## SUBDIVISION REVIEW SHEET

**CASE NO.:** C8-2017-0308.0A**Z.A.P DATE:** January 15, 2019**SUBDIVISION NAME:** Cogbill Subdivision**AREA:** 0.83 acres**LOT(S):** 4**OWNER/APPLICANT:** Kirk Smith**AGENT:** Stansberry Engineering  
(Blayne Stansberry)**ADDRESS OF SUBDIVISION:** 1001 and 1003 Cogbill Street**GRIDS:** ML31**COUNTY:** Travis**WATERSHED:** South Boggy Creek**JURISDICTION:** Full Purpose**EXISTING ZONING:** SF-2**District #:** 5**PROPOSED LAND USE:** Commercial/residential**ADMINISTRATIVE WAIVERS:** None

**SUBJECT:** Lots 7 and 8 Cogbill Resubdivision, Flag Lot Variance Request

Re: Resubdivision of Lots 7 & 8, Cogbill Subdivision, C8-2017-0308.0A  
Variance Request to §25-4-175, Flag Lots

# RESUBDIVISION OF LOTS 7 & 8 COGBILL SUBDIVISION

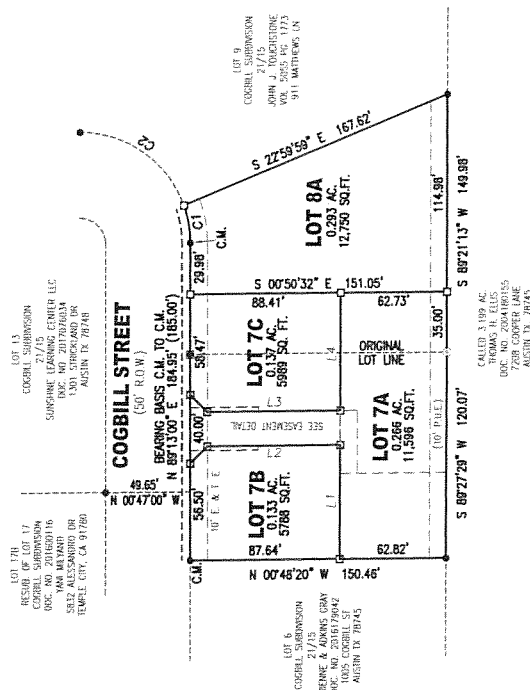
**VARIANCES:** The applicant requests a variance from LC Section 25-4-175 in order to resubdivide property utilizing a flag lot design. **RECOMMENDED.** (See attached staff memorandum).

**DEPARTMENT COMMENTS:** The request is for the resubdivision of lots 7 and 8, Cogbill subdivision consisting of 0.83 acres. The applicant proposes to resubdivide two existing lots into four lots for residential use, (note proposed Lot 8A is currently an existing, legally non-conforming, plumbing supply business). The proposal includes one lot, (proposed lot 7A) with a flag lot design. All proposed lots will take access to Cogbill Street. Proposed lots 7A, 7B and 7C will share a joint use access easement at the flag pole. All City of Austin utilities are available. The applicant will be responsible for all costs associated with any required improvements.

The applicant has requested a variance from LDC Section 25-4-175(A)(2) in order to resubdivide a lot utilizing a flag lot design. Staff evaluated the variance request based upon the following criteria:

The fire department has reviewed and approved the design.

The utility layout has been reviewed and approved.

Environmental and arborist review has approved the design.

The flag lots residential use is consistent and compatible with the surrounding neighborhood.

**STAFF RECOMMENDATION:** The staff recommends approval of the plat subject to the granting of the above referenced variance request. This plat otherwise meets all applicable State and City of Austin LDC requirements.
